County of Fairfax, Virginia

STAFF REPORT

SPECIAL PERMIT APPLICATION NO. SP 2009-SU-066

APPLICANT/OWNER: Harvest Chinese Christian Church

LEFT TURN LANE DESIGN AND TRUCK TURNING RADIUS ANALYSIS

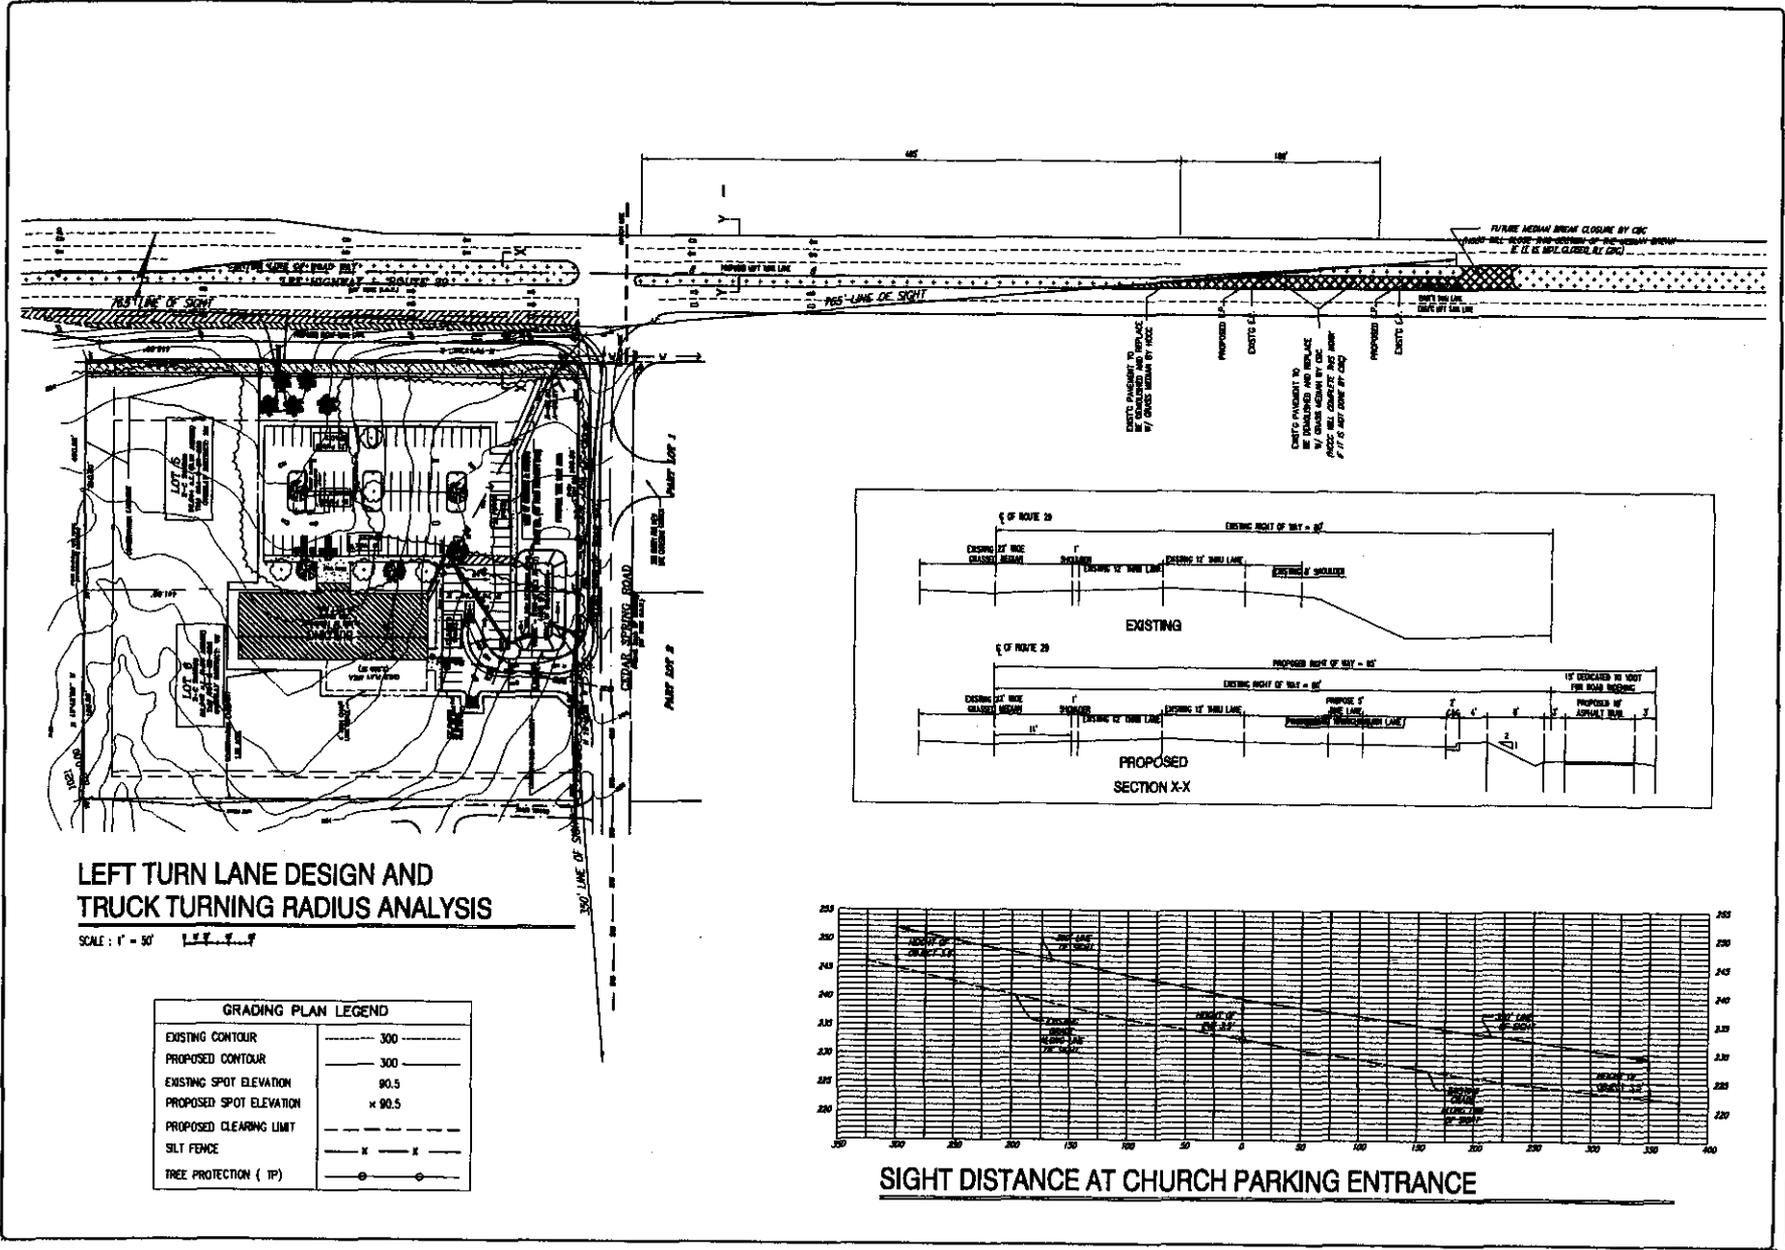
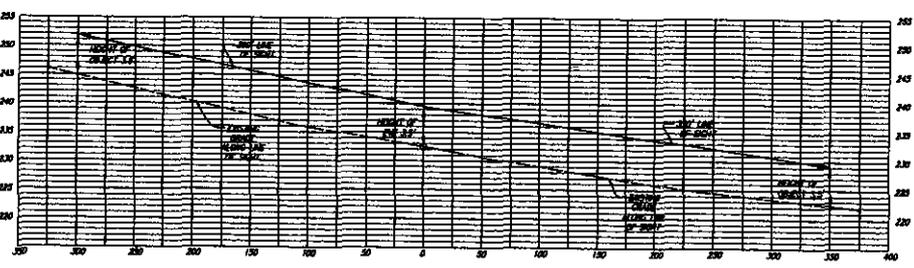
1. Provide Right of Way dedication and construct the improvements on Route 29 according to Route 29 Feasibility Study (Fairfax County, May, 1992).
2. According to the Fairfax County Comprehensive plan, a third through lane eastbound along Route 29 and right turn lane to Cedar Spring Road should be provided along the site's frontage.
3. Left turn lane with required taper should be provided along Rte. 29 for the site.
4. Adequate Right of Way for 10' Trail should be provided along site's frontage.
5. A separation with a raised median between EB and WB Rte. 29 is necessary as per Fairfax County Comprehensive plan.
6. The applicant should submit an Access Management Design Exception for the proposed substandard spacing of the entrance from Rte. 29/Cedar Spring Road intersection.
7. Rte. 29 traffic volume and trip generations from the site should be noted on the plat.

8. Coordination of this site is required with Fairfax County Site Plan # 1768-SP-001-3 (New Life Christian Church).
9. Proposed entrance across Cedar Spring Road and all design details from the above mentioned site plan should be shown on this plat.
10. Interparcel connection to the adjacent school site should be checked. If such a connection is provided by the school, the applicant should complete it in order to gain an access to the Pleasant Valley Road signal.

In accordance with the Fairfax County Comprehensive, the Route 29 (Lee Highway) Feasibility Study and the Virginia Department of Transportation (VDOT) standards, the applicant was required to provide a significant number of road improvements along Lee Highway as the property fronts both Lee Highway and Cedar Spring Road. The proposed road improvements include, but are not limited to, constructing a third eastbound thru-lane which will serve as an eastbound right-turn lane onto Cedar Spring Road from Lee Highway, an eastbound 5-foot wide on-road bike lane and a 10-foot wide paved trail along the site's Lee Highway frontage. Other road improvements include providing a raised median between eastbound and westbound Route 29 traffic lanes, a westbound left-turn lane and corresponding taper and closure of the existing median break east of the proposed left-turn lane. The applicant received approval from VDOT to modify the right-turn lane taper length shown in Appendix 8 of the staff report. The applicant has agreed to provide the required road improvements and staff has proposed a development condition to ensure that these commitments are fulfilled.

LANDSCAPING PLAN
SCALE: 1" = 30'

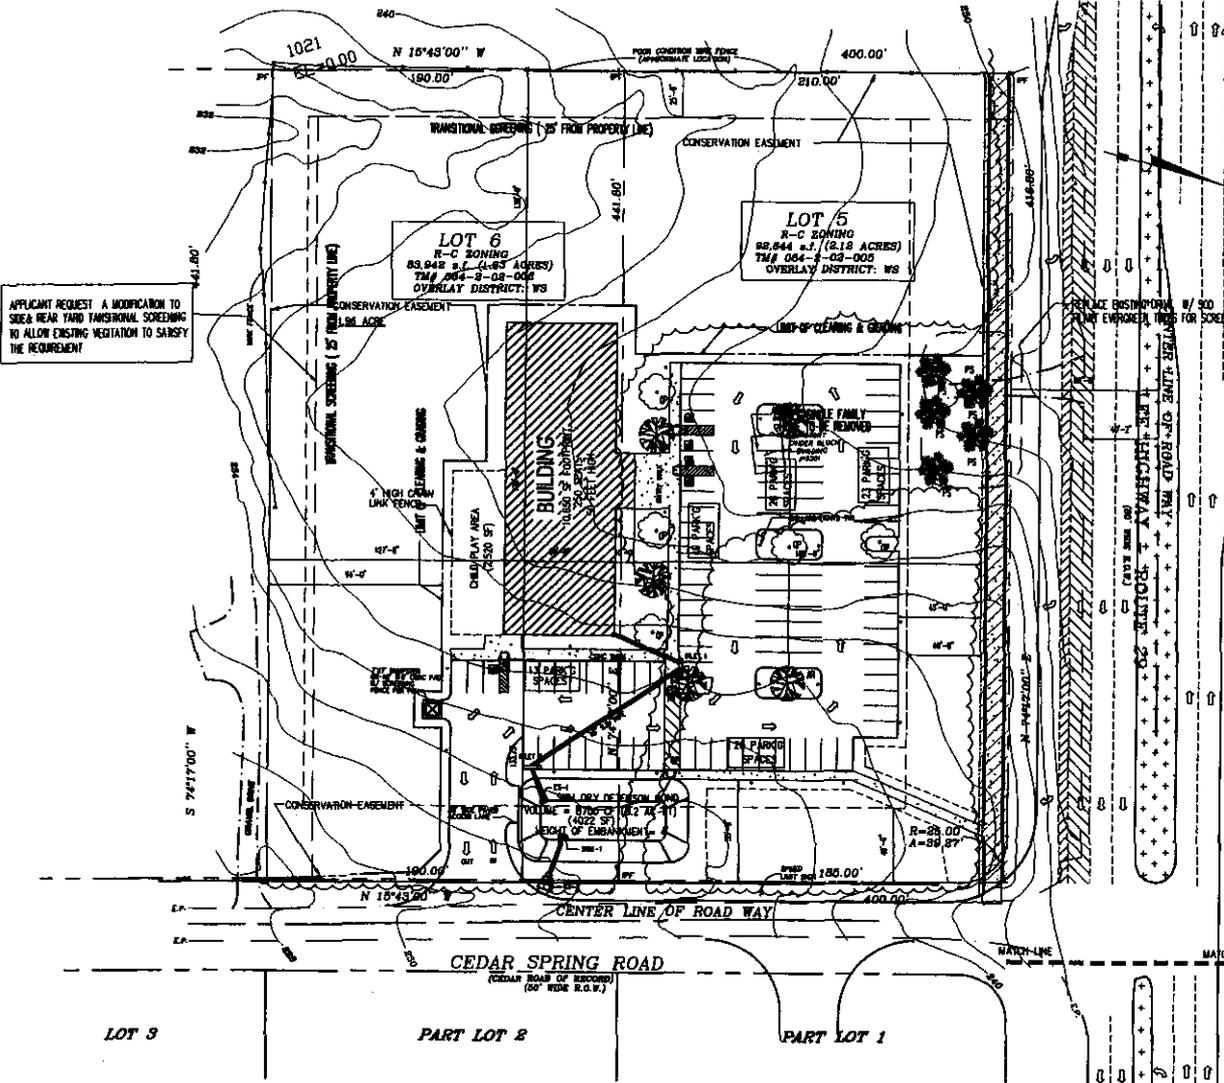
APPLICANT REQUESTS A MODIFICATION TO SPEC. REAR YARD TRANSITIONAL SCREENING TO ALLOW EXISTING VEGETATION TO SATISFY THE REQUIREMENT

Basis: Item 3 of Par. 3 of Sect 13-305 of Zoning Ordinance states that transitional screening and barrier requirements may be waived or modified where the building, a barrier and/or the land between that building and the property line has been specifically designed to minimize adverse impact through the combination of architectural and landscaping techniques. The applicant proposed to retain existing dense natural vegetation along the boundaries of the site. The width of existing vegetation along the boundary of site all exceeds the minimum 25 feet width of transitional screening requirement. On northern boundary where the existing driveway will be replaced, the area will be re-vegetated with evergreen trees (See drawing SP-4).

Staff has proposed a development condition requiring the applicant to provide supplemental evergreen tree plantings within areas where the application property abuts residential lots to provide viable, year-round vegetative screening as determined by Urban Forest Management Division (UFMD). With adoption of the proposed development conditions in Appendix 1, staff believes this issue will be addressed.

Staff does not object to modifications of the transitional screening and/or modifications and a waiver of the barrier requirements to allow existing vegetation, except that additional vegetation should be provided along the property lines adjacent to residential lots as determined by UFMD. Staff has proposed a development condition to address this issue.

Existing vegetation shall be used to meet the required transitional screening requirements along the southern and northern lot lines. In addition to the trees preserved in Tree Save Area 1 along the southern lot line, supplemental vegetation shall be planted generally between the south side of the church building and the Tree Save Area. If determined necessary by staff from the Urban Forest Management Division (UFMD), DPWES to further supplement existing vegetation, vegetation may be planted in the Tree Save Areas, but only the species and in the numbers and locations as determined by UFMD.

**PRELIMINARY STORMWATER MANAGEMENT PLAN
 POST-DEVELOPMENT CONDITION**

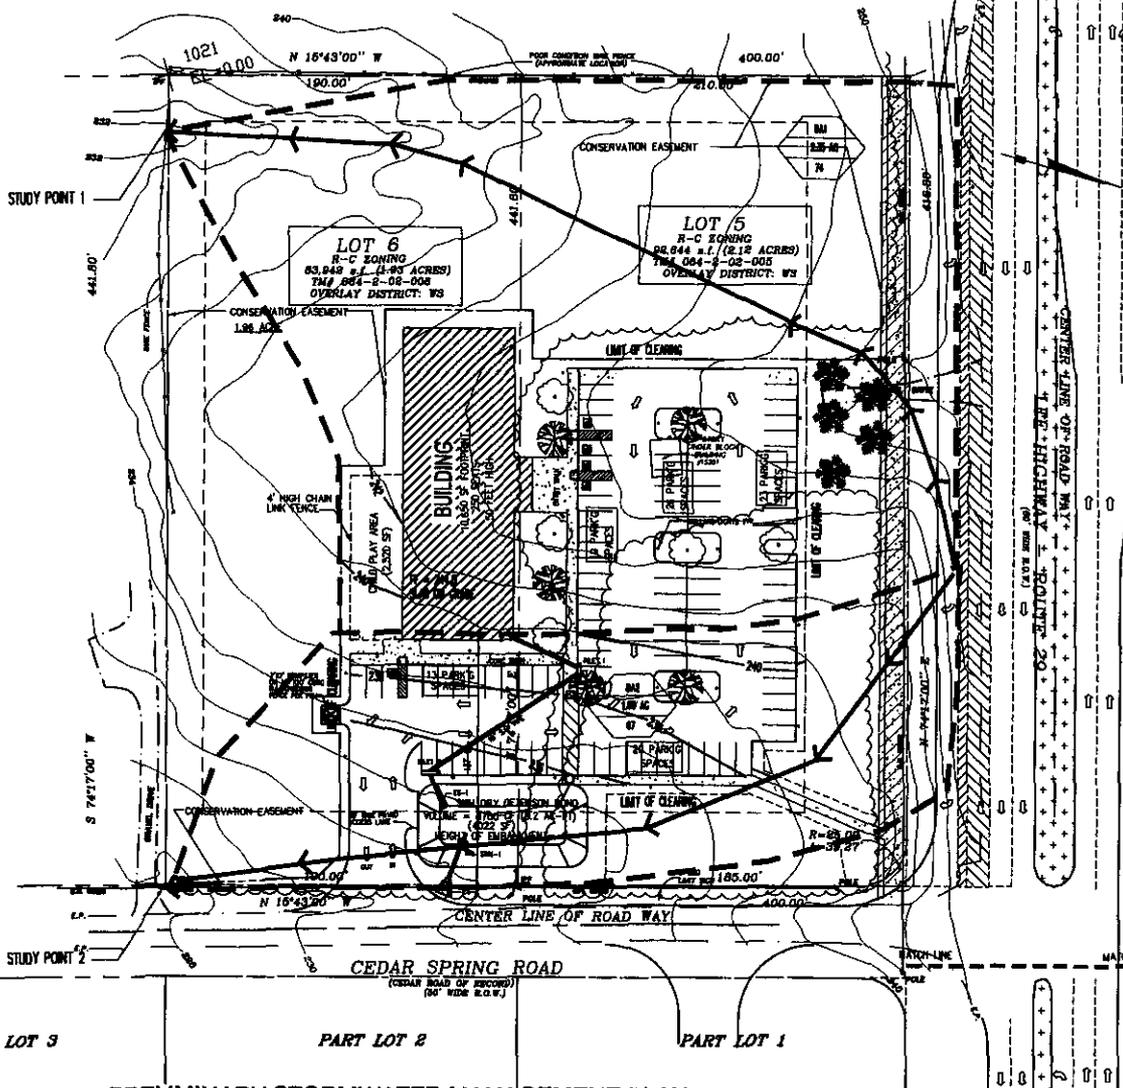
A dry pond has been proposed to provide stormwater detention for this project; it has been located on the plat. The majority of the runoff from the building and the parking lot should be able to flow to the pond; the post-development drainage will not shift (ZO 8-011.2.J(1)(b)). The access easement to the pond must be 20 feet wide (ZO 8-011.2.J(1)(d), PFM 6-1606.2G). While the location of the pond's outlet pipe is shown, any inlet pipe and the preliminary layout of the rest of the on-site drainage system are not shown (ZO 8-011.2.J(1)(c)). As shown, the channel improvements necessary for the emergency spillway would likely impact the conservation easement. The time of concentration on this property is less than 0.17 hours (PFM Plate 4-6).

24. Stormwater Management (SWM) measures may be provided via a dry detention pond as shown on the SP Plat as determined by DPWES. The majority of Best Management Practices (BMPs) shall be met through a conservation easement placed over the Tree Save Areas (to be known as perpetually undisturbed open space) shown as Tree Save Area 1 and Tree Save Area 3. The remainder of required BMP will be met through natural or structural systems. If a modification of the PFM to permit the proposed stormwater management/best management practices as shown on the SP Plat is not granted by DPWES and SWM/BMP facilities in substantial conformance with the SP Plat cannot be provided, then a special permit amendment (SPA) shall be filed to provide water quantity and quality control measures in accordance with the PFM as determined by DPWES.
